## La Quinta Residents for Responsible Development Say NO to the Wave - [saynotothewave.com](http://saynotothewave.com)

**RE: Statement on the Non-Certifiability of the Coral Mountain FEIR**

Presentation 2 - Executive Summary of Noise Study

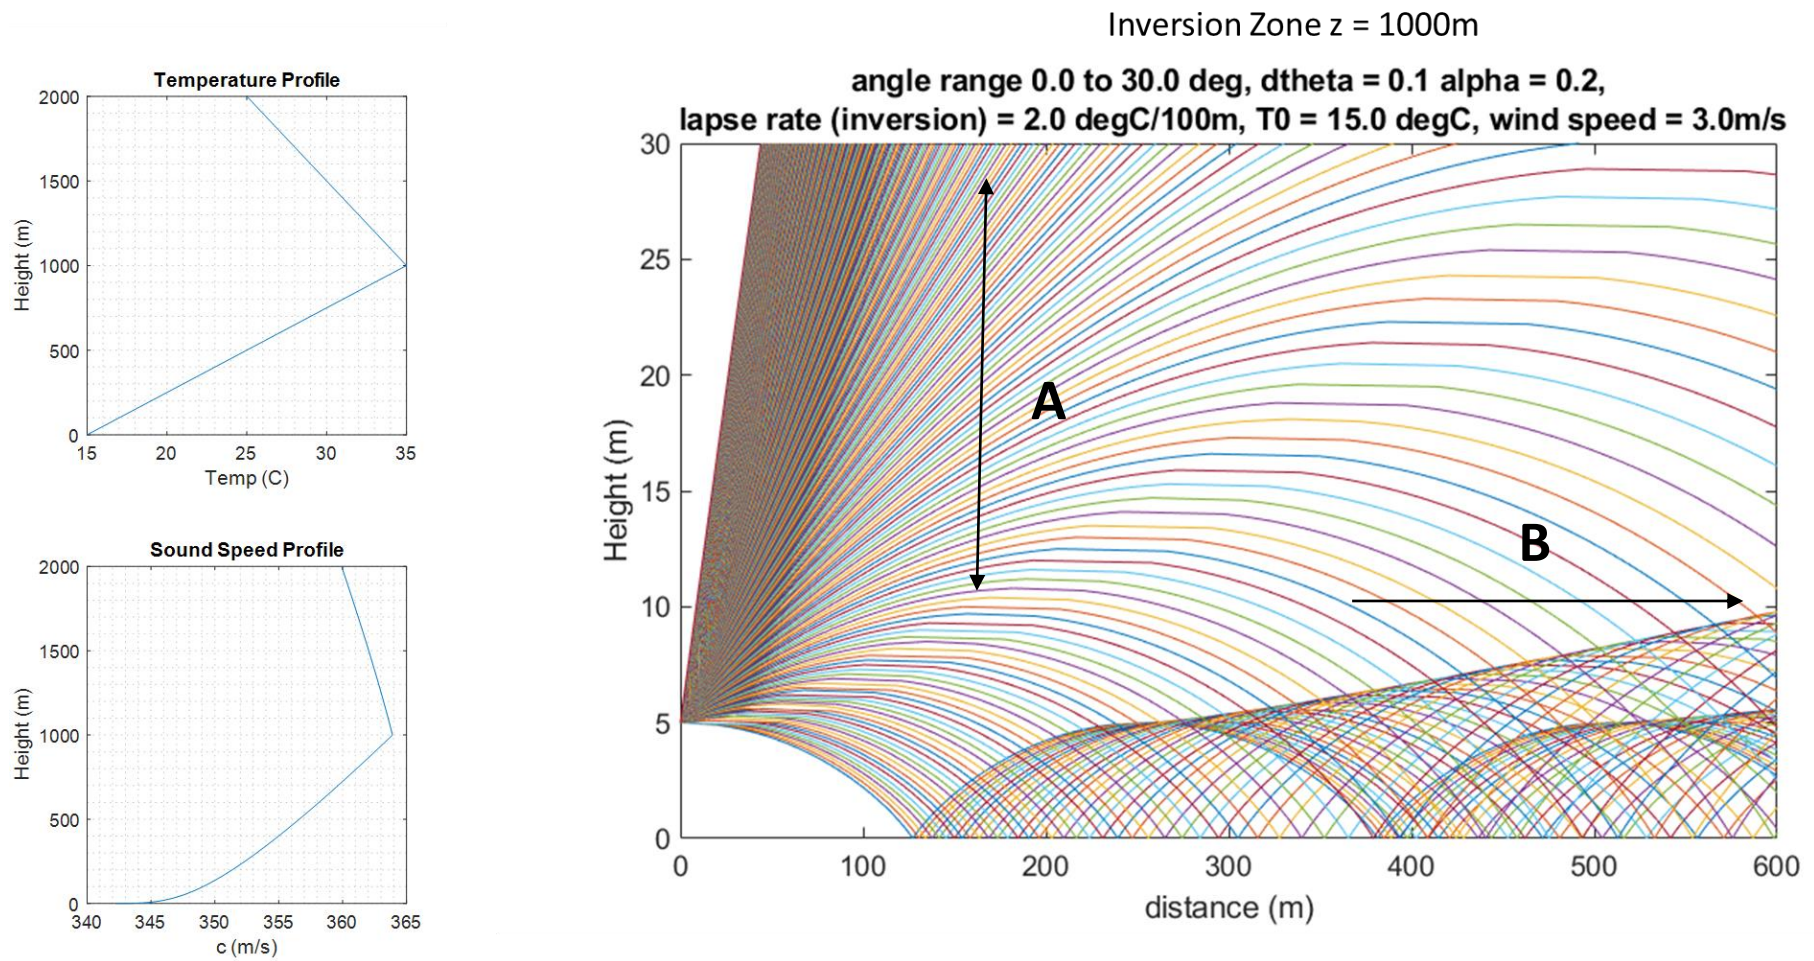
Figure 3, Figure 4 and Figure 5 illustrates 3 different inversion scenarios for a source at 5m height with inversion layers at 300m and 1000m with a moderate downwind speed of 3m/s and different wind shear constants. The plots have been generated with custom ray tracing code written in MATLAB. The inversion layer at 300 m represent the worst case scenario, and inversion layer at 1000m represents a likely scenario.

# Line of Sight Study is Flawed

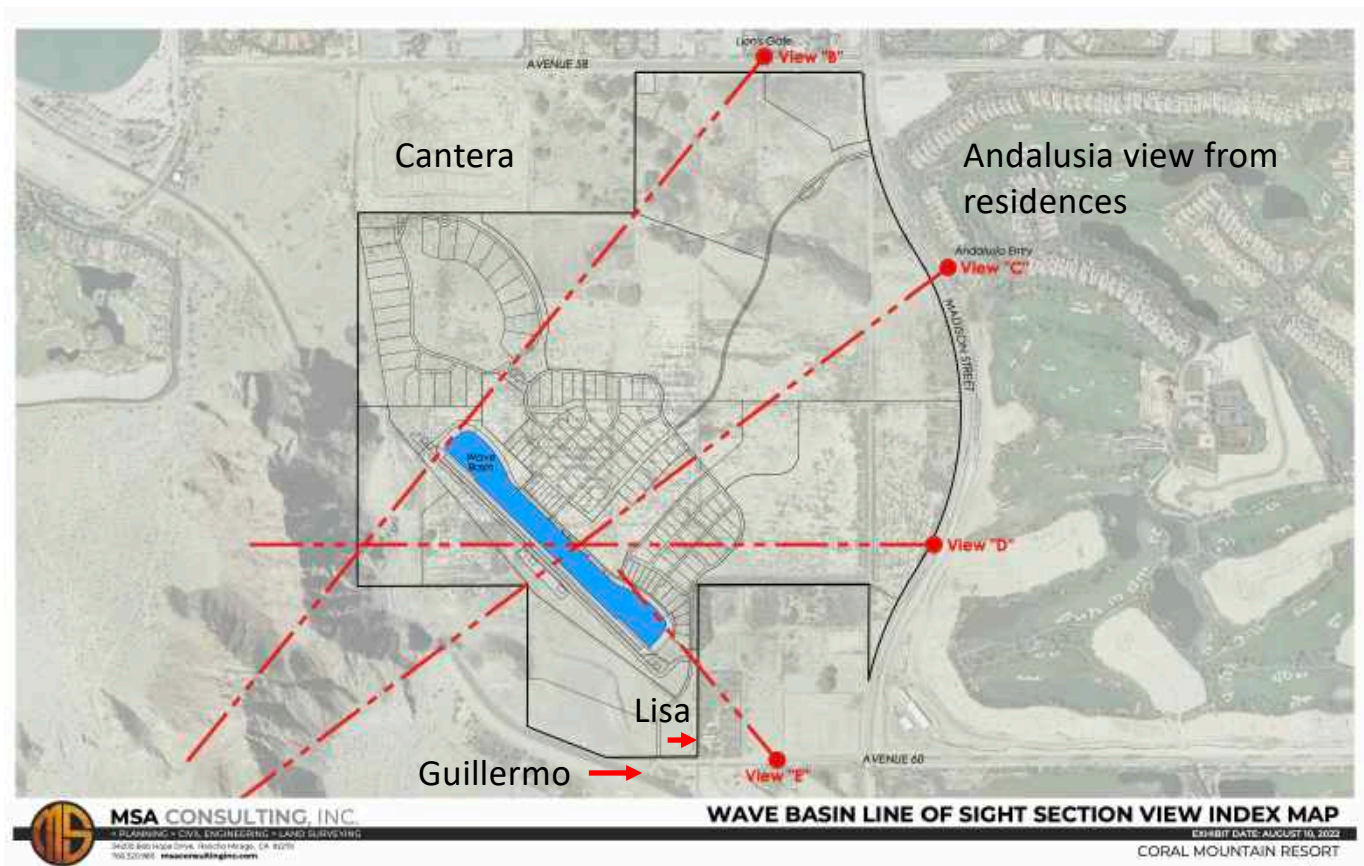
The Red Dots show the origination points of the Line of Sight study. I have additionally annotated on this picture Lisa Castro's and Guillermo Casillas' houses, Cantera & the view site from residences at Andalusia.

- Why is the developer only doing line of sight studies from the street?
- You should care about what is happening to people **WHO DID NOT EXPECT THAT OUR CITY COUNCIL MIGHT CHANGE THE ZONING THAT WOULD CAUSE THIS TO HAPPEN!**

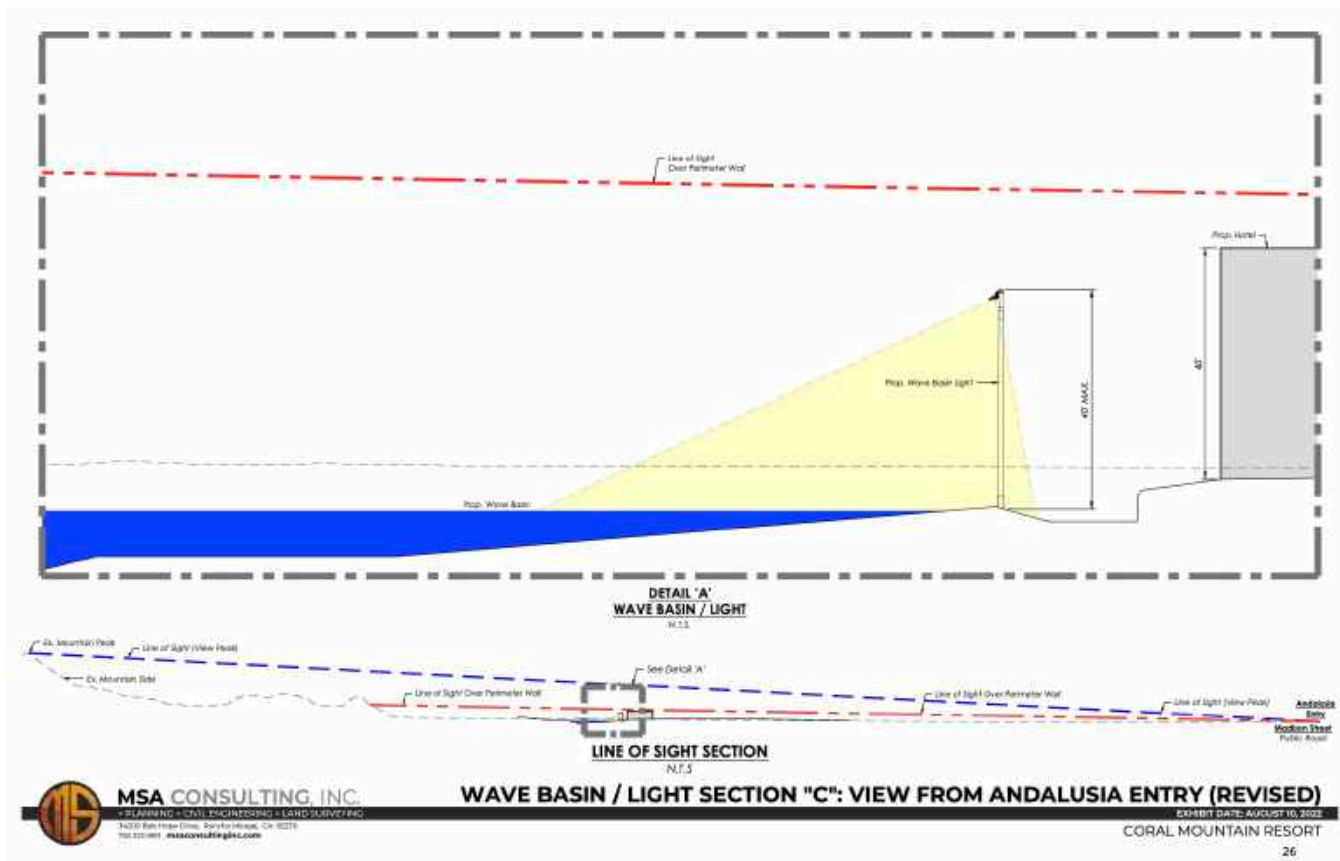
Here is the Line of Sight View from the Andalusia Entry, which is on the right side of this picture, and illustrates that there will be no light visible from the entry.

Here is the view of Coral Mountain from residences at Andalusia, 365 days of the year, from dusk until 10pm or later. The arrows show balloons which represent lights, only on the north side of basin
